Technical Service Bulletin (TSB)
Fuel Injector Leak

REFERENCE:	TSB: 14-009-25 REV. B GROUP: 14 - Fuel System	Date:	November 8, 2025	REVISION:	14-009-25 REV. A
VEHICLES AFFECTED:	2022 - **2025** (B1) Jeep Renegade 2022 - **2025** (H1) Jeep Commander 2022 - **2025** (M1) Jeep Compass This bulletin applies to the vehicle built on or before **July 31, 2025 (MDH 0731XX)** equipped with a 1.3L I4 Turbo MAIR DI Engine w/ESS E100 (Sales Code EYJ).			MARKET APPLICABILITY: ☐ NA☐ MEA ☒ SA☐ IAP ☐ EE☐ CH NOTE: **This bulletin applies to the South America market.**	
CUSTOMER SYMPTOM:	Customers must experience a Malfunction Indicator Lamp (MIL) illumination and the vehicle must exhibit/set one or more of the following Diagnostic Trouble Codes (DTCs): - P0087-00 - Fuel Line Pressure Sensor - Bank 1 - Pressure Below Limit. - P0300-00 - Multiple Cylinder Misfire. - P0301-00 - Cylinder 1 Misfire. - P0302-00 - Cylinder 2 Misfire. - P0303-00 - Cylinder 3 Misfire. - P0304-00 - Cylinder 4 Misfire. - P006C-00 - Air Pressure and Temperature Sensor - Correlation. Customers may also comment on one or more of the following: - Unstable idle. - Abnormal engine noise.

Fig. 1
Spark Plugs

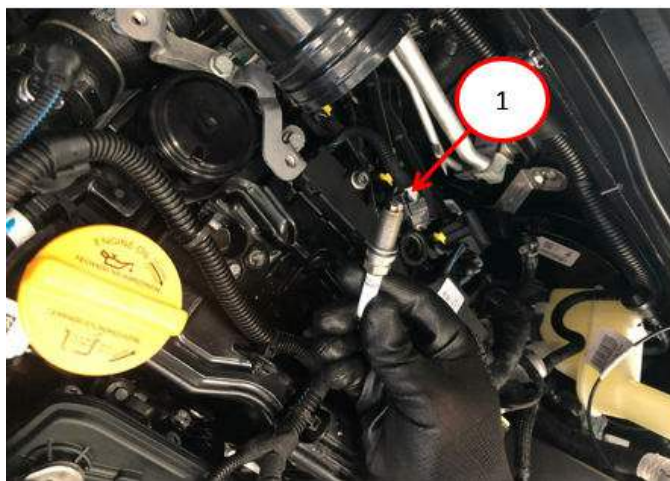
1. Remove the spark plugs [Fig. 1](#). Refer to the detailed service procedures available in DealerCONNECT/Service Library under: Service Info> 5510D10 – Velas de ignição – Remoção e Recolocação.

Fig. 2
Endoscope

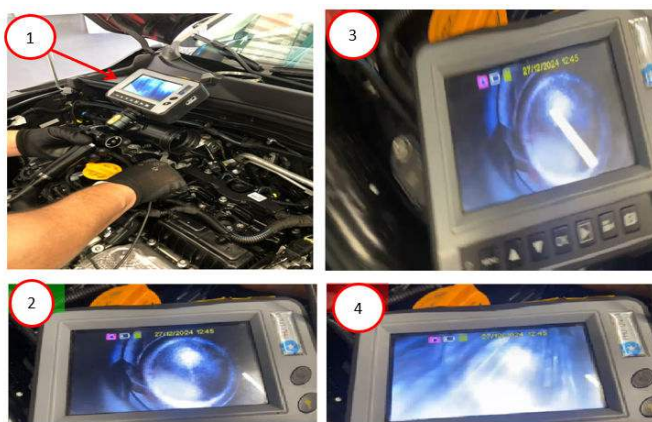
2. Using an Endoscope, check all injectors [Fig. 2](#). With the help of a collaborator, ask helper to turn the ignition key without starting the vehicle. **Keep the ignition on for one minute per injector.**
